REQUEST FOR PROPOSAL - ADDENDUM 1
Question & Answer

Applicant	**Coweta Indep School Dist 17**
BEN	140174
Form 470 #	**270002927**
470 Description	COWE OK C2 RFP 2728 IC
Addendum #	1
Date Posted	11/20/2026
e-Bidding Link	https://kellogglc.bonfirehub.com/portal

Coweta Public Schools
Child Nutrition
Single-mode
Fiber
Coweta Central Elementary School

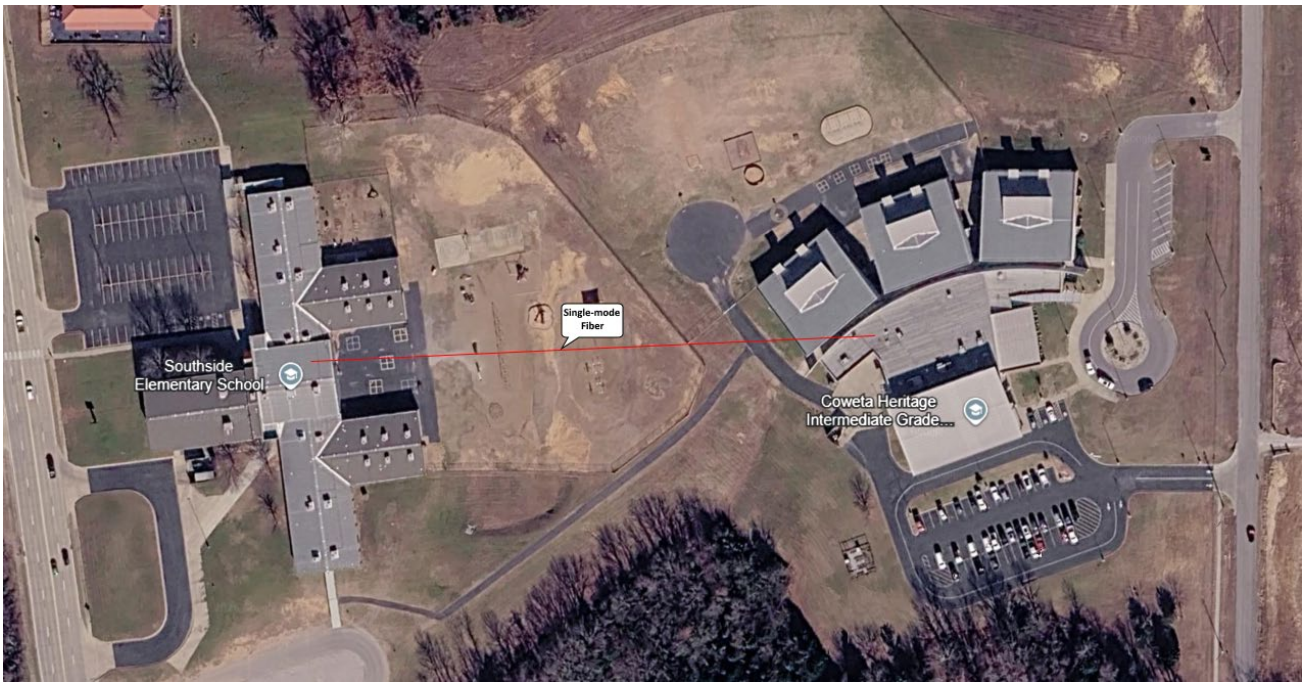
Question: Can you email us digital copies of the maps you handed out at the walkthrough?

***Answer:** Please see attached three maps.*
